# Tivoli MFG Ltd.

## Service Bulletin

Ride Type: Spin Out  
Date: September 8, 1998

OPLOSSING  
SOLUTION

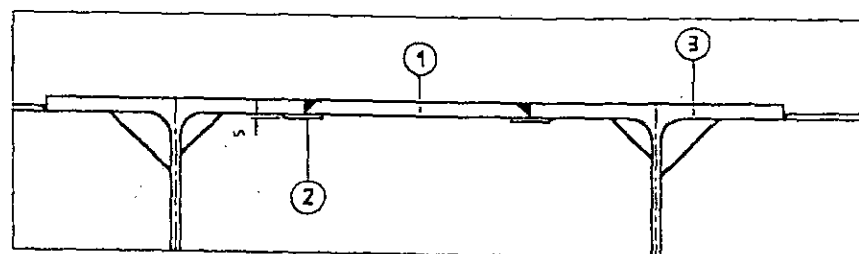
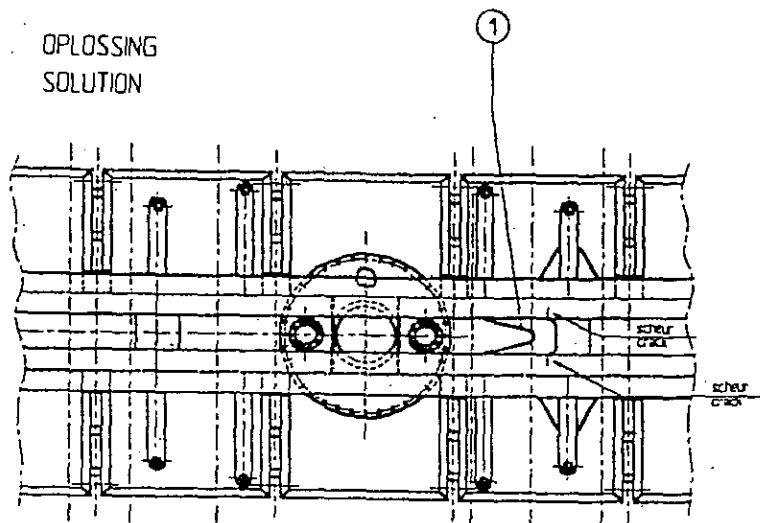
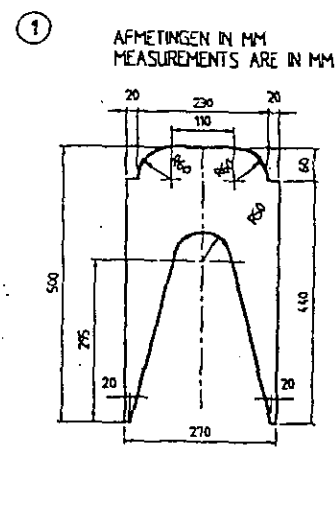
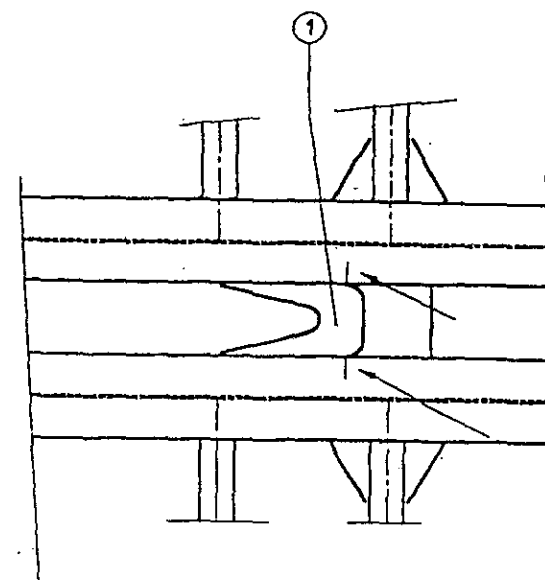
It has come to the attention of **Tivoli Mfg. Ltd.** from the original designers of the Spin Out, **KMG Europe BV**, that there has been cases where cracks have been detected on the center I beam of the rotating base frame as described in the accompanying drawings.

If cracks are detected as described in the attached drawings complete repair procedures as described below by repairing crack and installing gusset plate.

1. Locate end of crack and drill a 1/4" hole through beam where crack ends.
2. Grind and clean out crack to about 1/8" of bottom of beam.
3. Weld up ground out crack and grind of weld flush with I beam.
4. Install gusset plate as described in attached drawings and weld in place.

1. LAS STRIP POS. 2 ONDER DE CHASSIS BALKEN POS. 3  
WELD PLATE POS. 2 UNDER THE CHASSIS BEAMS POS. 3
2. LAS PLAAT POS. 1 IN DE TRAILER  
WELD PLATE POS. 1 IN THE TRAILER
3. REPARERE DE SCHEUR DOOR DE SCHEUR UIT TE SLIJPEN EN DICHTE TE LASSEN  
REPAIR THE CRACK BY GRINDING OUT THE CRACK AND WELD THE HOLE.

### Arm Slewing ring inspection and lubrication supplement

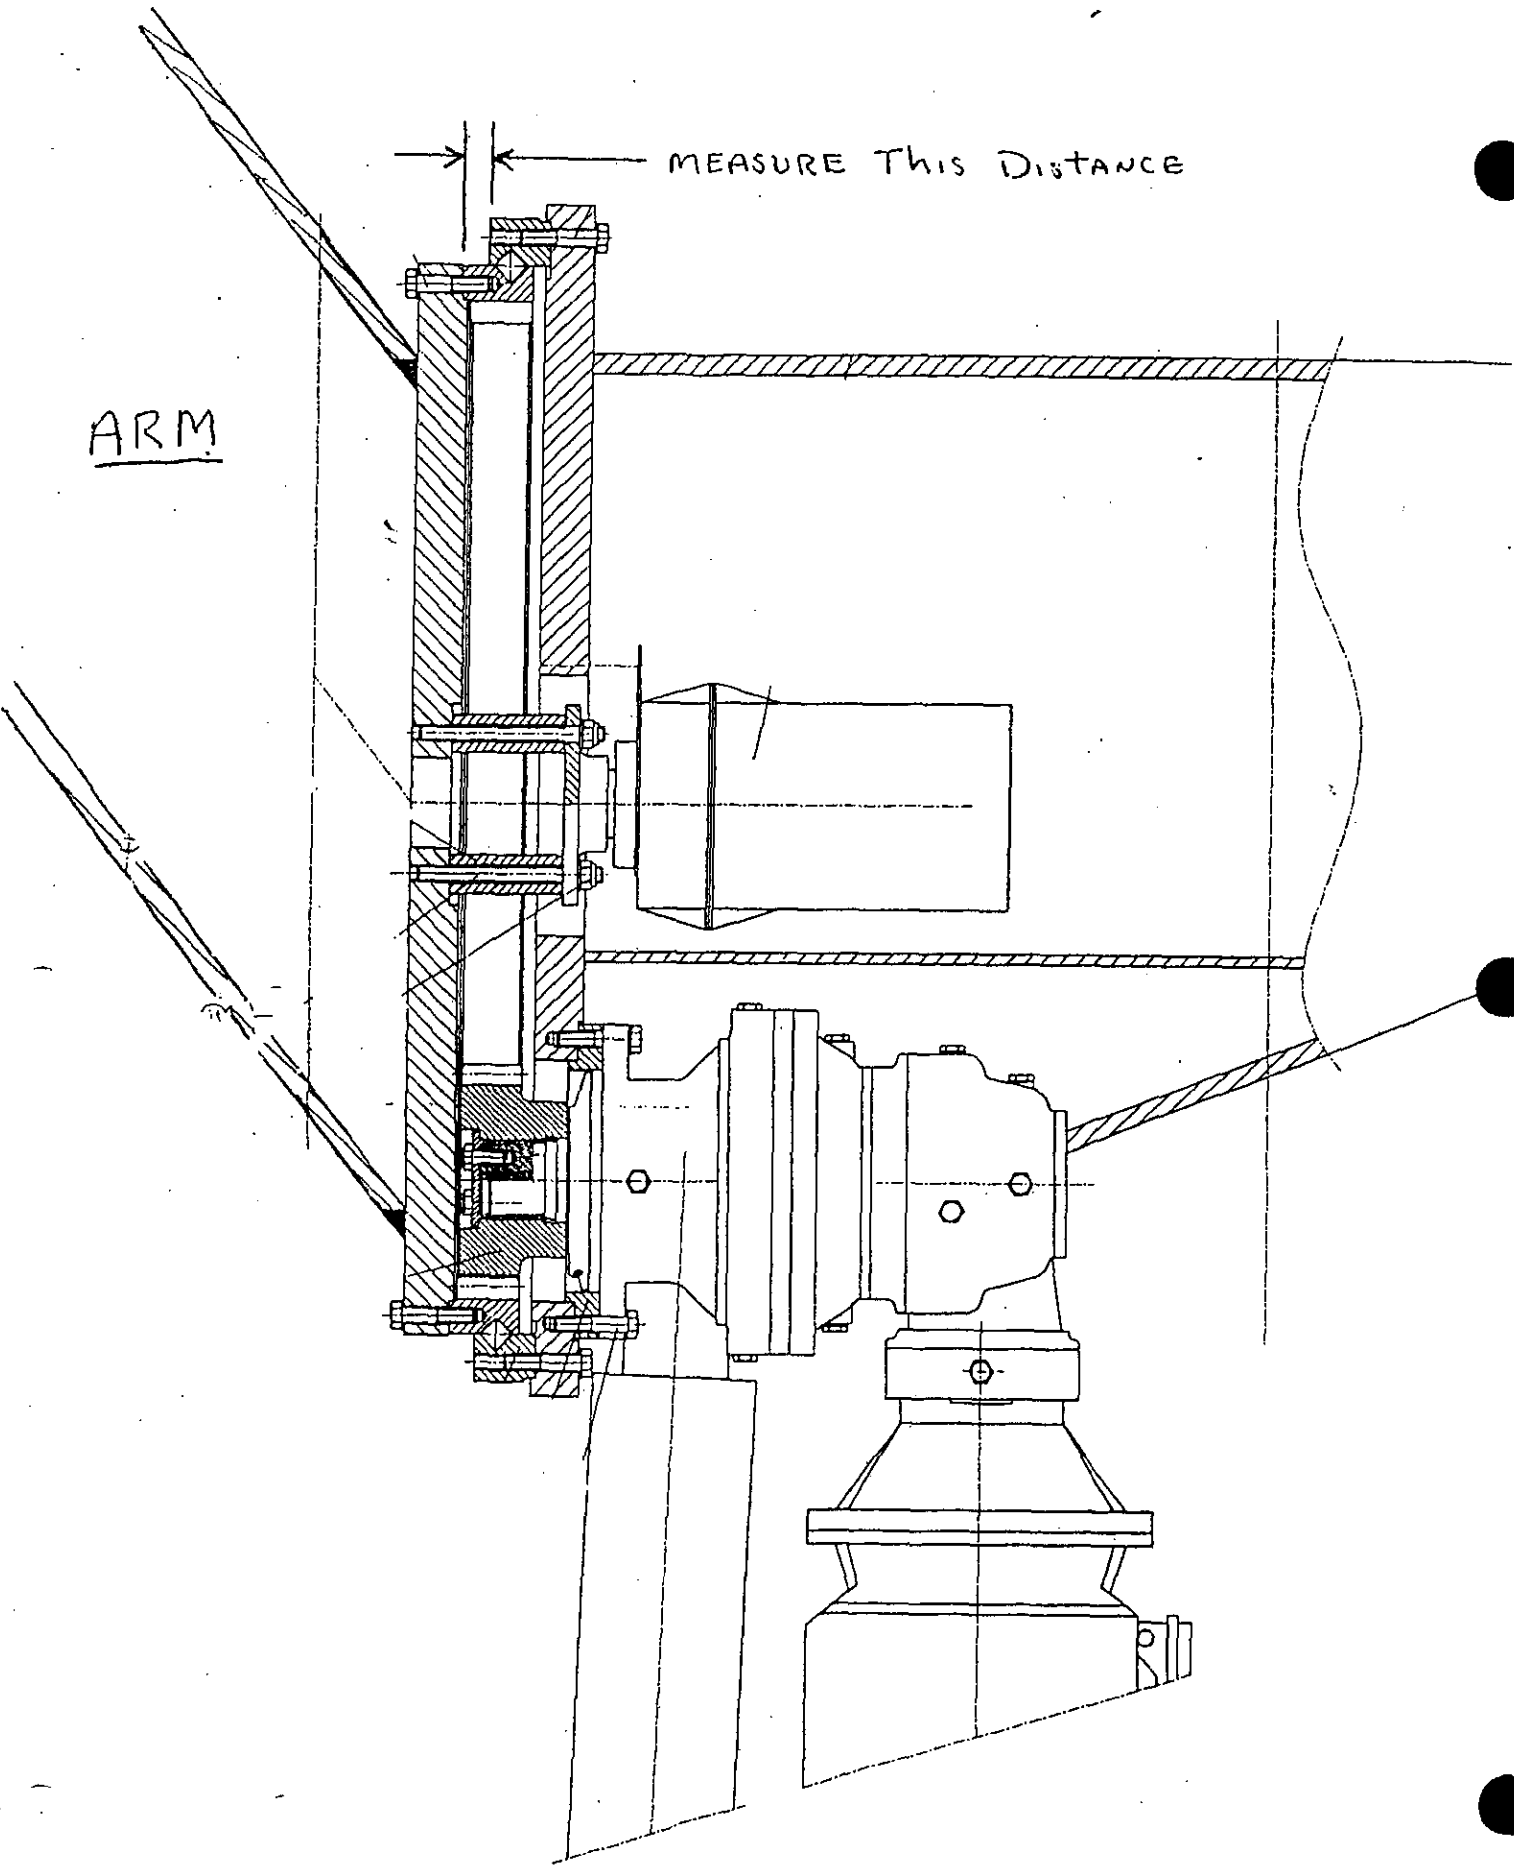
Measure the distance as described on page 2 at the 12:00 O'Clock position of the arm slewing ring and record measurement in ride log book. Check this measurement on a monthly bases. If the measurement increases over 1/8" the bearing is wearing to a point that it must be replaced.

If the bearing is starting to wear metal filings will be noticeable in the grease around the seal. Inspect this on a weekly bases.

Fig. 1

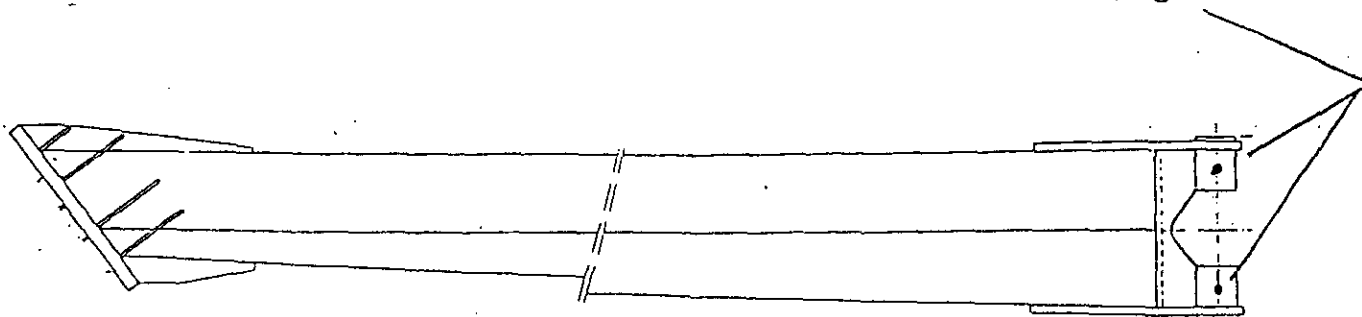
Tivoli Manufacturing Ltd. has become aware of some rides where the hinge / attachment pins used to hold the sweep to the center hub have become tight and make folding the sweep up for set up or tear down difficult. Tivoli Manufacturing Ltd. is recommending that grease fittings be installed in the pin sweep hub of the four (4) sweeps that pivot on their pin when folding.

1. With both pins installed in sweep, Remove the threaded collar from the bottom of the pin below the sweep hub. This requires the removal of a set screw locking the collar to the threads.
2. With the other pin slightly loosend, remove hing pin by tapping out with hammer and brass or alluminum rod.
3. After pin is removed drill a 3/16" hole through the center of the sweep bushing collar so the hole comes through between the two internal bushings.
4. After all 3/16" holes are drilled 2 per sweep, 8 total, counter bore a 21/64 hole approximately 10mm deep ( 3/8" ). As in step 1 use a shop vac to collect filings while drilling.
5. Tap counter bore with a 1/8" pipe tap, Clean toughly.

6. After installing grease fitting lubricate with a good quality lithium grease on a weekly bases.

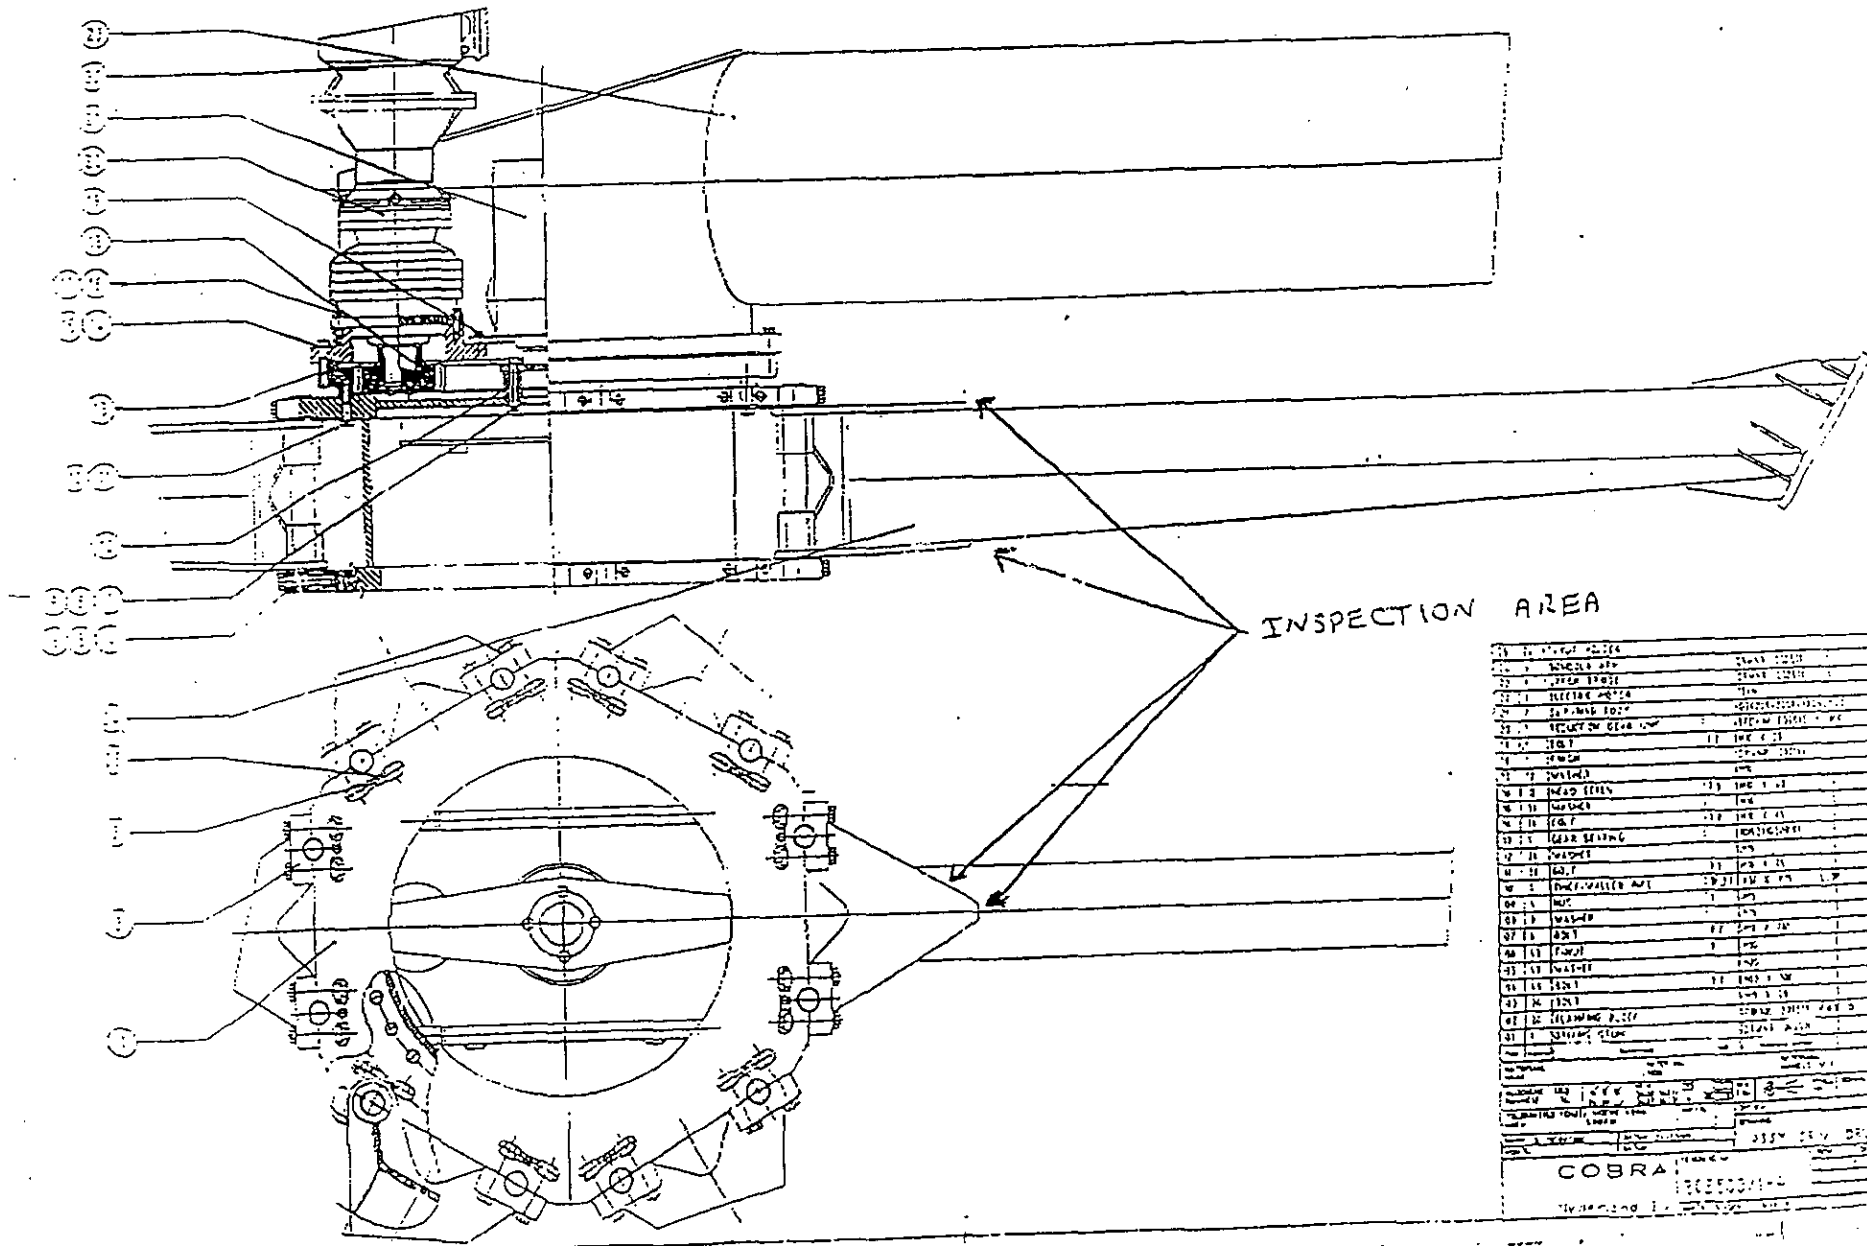
Tivoli Mfg. Ltd requires that all operators inspect the areas indicated on the attached drawings. If cracking is detected please report to AmTech / Amusement tech. intl. Inc. at 817-641-5045 for repair procedures and gusset kits.

As of the date of this bulletin gusset plates are not required unless cracking is detected. Rides manufactured to operate in Europe are run at different speeds than those operated in the USA, making it possible that this problem may only be applicable to rides operating in Europe. Please report to AmTech after inspection whether cracks are detected or not so proper action can be taken.

If no cracks are detected as described in the attached drawing, a monthly inspection of this area of the sweeps should added to your existing inspection procedures.

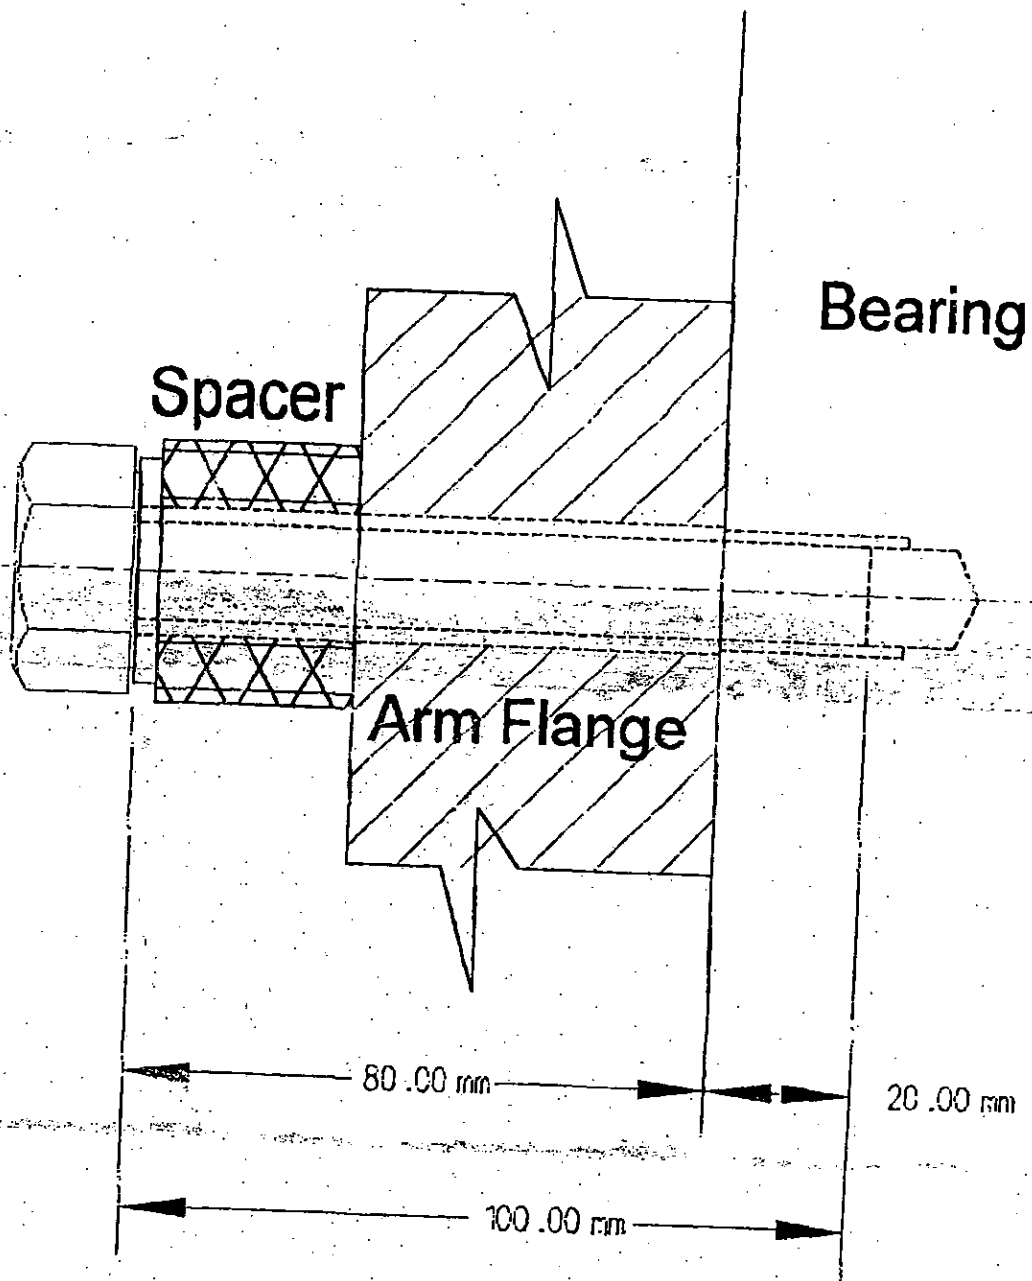
It has come to the attention of Tivoli Mfg. Ltd. of an instance where two of the arm to bearing attachment bolts had broken. Though this has happened on only one ride, Tivoli Mfg. Ltd in the interest of safety has decided to provide a bolt upgrade kit to be installed on all 36-bolt arm bearings.

These bolts and spacers, along with the hardened flat washers removed from the bolt removed must be installed as shown on the accompanying drawing.

Replace all bolts one at a time in a star pattern around the bearing until all 30 bolts have been replaced.

Torque all bolts to 210 ft Lbs.

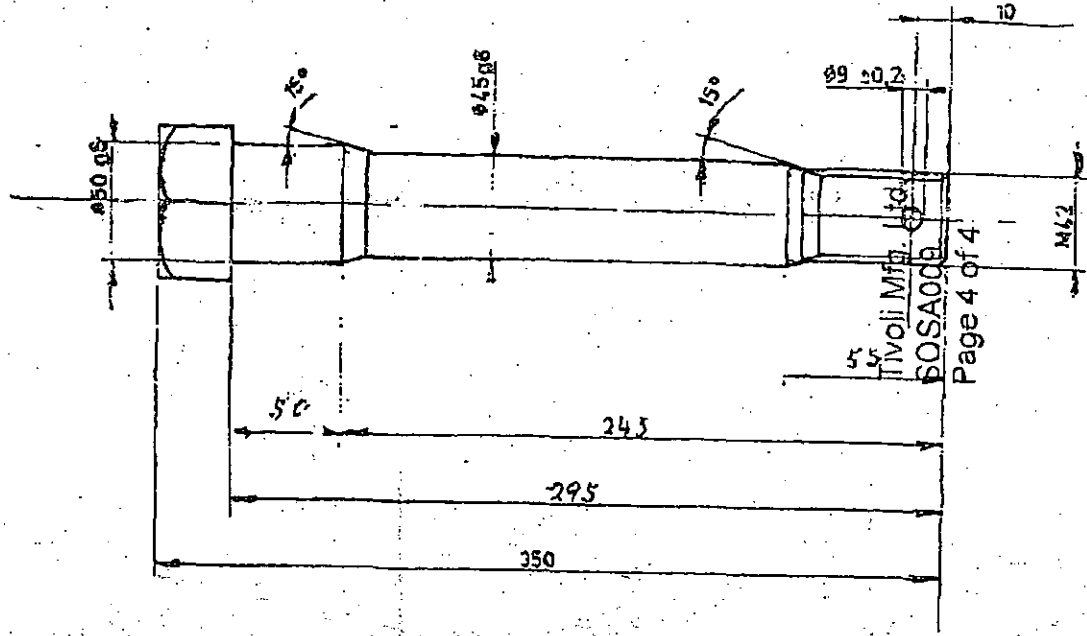
**Removable sweep pins.** Only pins installed and removed each time ride is set up [four (4) pins]. See drawing HATC-W003 Attached.

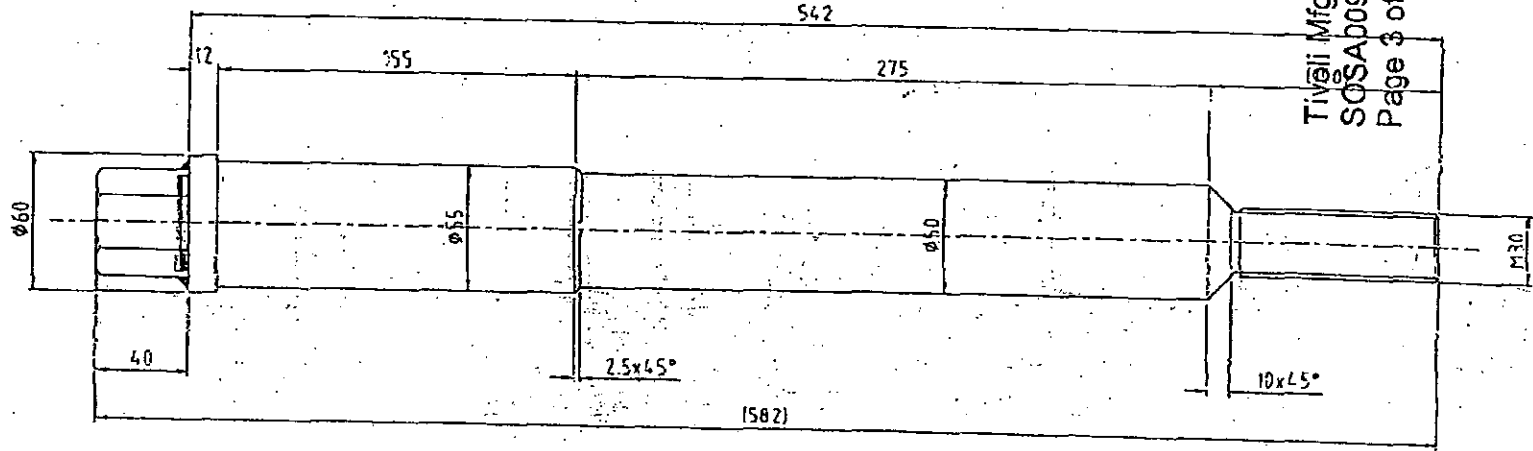
**Vehicle attachment Pins.** (If ride is equipped) Two pins per Vehicle (See drawing 3-203005 attached). **Note:** Earlier rides were manufactured with 10 bolt flange vehicle connections and are not included in this inspection.

Figure 1

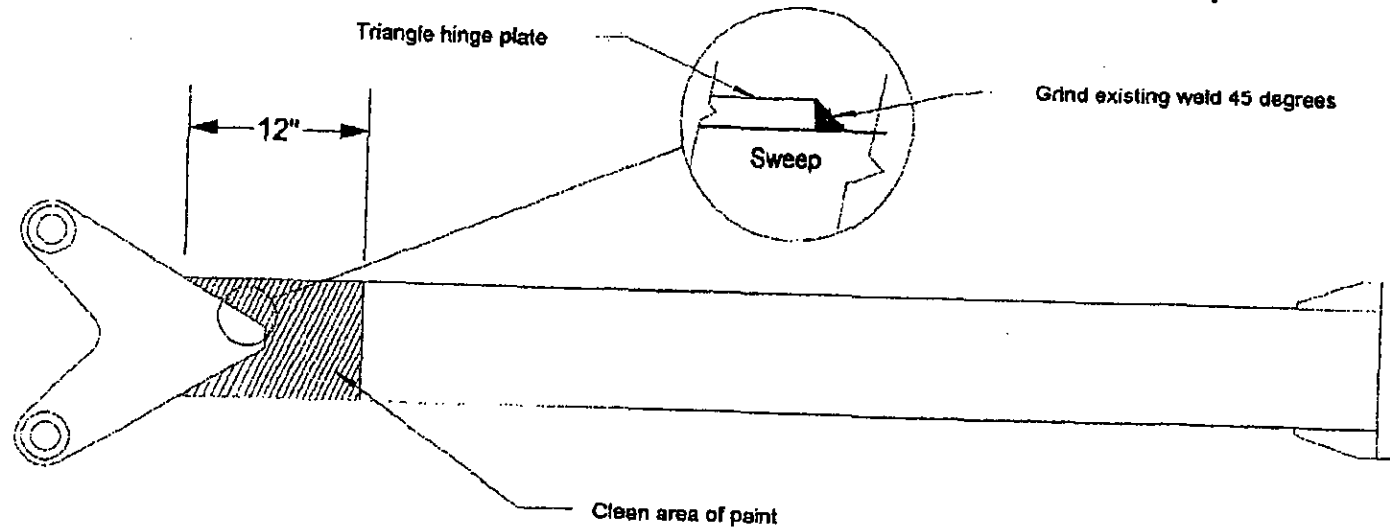
- Step 5: Grind weld around triangle hinge plate (See figure 1 Drawing SOSA010C) so weld is about 45°.
- Step 6: lay Gusset plate approximately 1/8 inch from base of weld on Triangular hinge plate. (See figure 2 drawing SOSA010C)

- Step 10: Grind weld on vehicle side of gusset as described in figure 2 drawing SOSA010C. Grinding must be transverse of the weld axis.
- Step 11: Peen weld with blunt instrument at the toe of the weld on top flat part of sweep as described in figure 2 drawing SOSA010C.
